Access Compliance Report

Public Rights-of-Way

(Curb Ramps)

Intersection ID: 48073	Main Street: MALLARD_HIGHLANDS_DR	Cross Street: MALLARD_GLEN_DR	Location: E
ADA ID: 3134FF6A794B	Ramp Type: PerpDiag	Initial Pass/Fail: Fail	Overall Compliance: No
Severity Score: 43.75			
Codes/Mitigation Info/Possible Solution		Field Measurements/Component Compliance

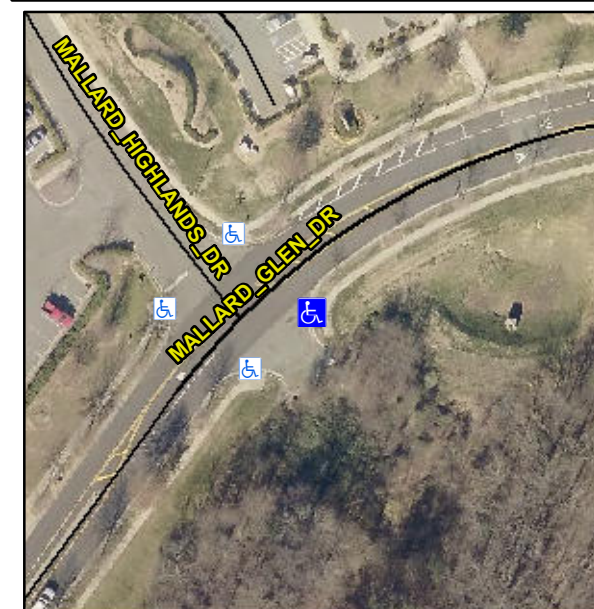
R304.5.1, R304.2.2, R304.5.3

Compliance	Description	Data	Compliance	Description	Data
N/A	Ramp Length (in)	64.0	No	Ramp Slope (%)	15.0
No	Ramp Width (in)	34.0	No	Ramp XSlope (%)	2.8
N/A	Flare Type LT	N/A	N/A	Flare Type RT	N/A
N/A	Flare Slope LT (%)	N/A	N/A	Flare Slope RT (%)	N/A
N/A	Flare Traversable LT?	N/A	N/A	Flare Traversable RT?	N/A
N/A	Landing Length (in)	N/A	N/A	DWS Provided?	N/A
N/A	Landing Width (in)	N/A	N/A	DWS Contrast?	N/A
N/A	Landing Slope (%)	N/A	N/A	DWS Length (in)	N/A
N/A	Landing X Slope (%)	N/A	N/A	DWS Full Width?	N/A
N/A	Landing Curb? (Y/N)	N/A	N/A	DWS Offset (in)	N/A
N/A	Shared Landing?	N/A			
N/A	Gutter Ponding?	N/A	N/A	Gutter Slope (%)	N/A
N/A	Gutter Lip Ht (in)	N/A	N/A	Gutter X Slope (%)	N/A
N/A	Painted X Walk1?	No	N/A	Painted X Walk2?	No
	X Walk 1 Direction	To NW		X Walk 2 Direction	To SW
N/A	X Walk 1 Width (in)	N/A	N/A	X Walk 2 Width (in)	N/A
	X Walk 1 Slope (%)	0.6		X Walk 2 Slope (%)	3.1
	X Walk 1 X Slope (%)	3.3		X Walk 2 X Slope (%)	0.5

Remove & Replace Curb Ramp With Two New Directional Ramps or Equivalent.
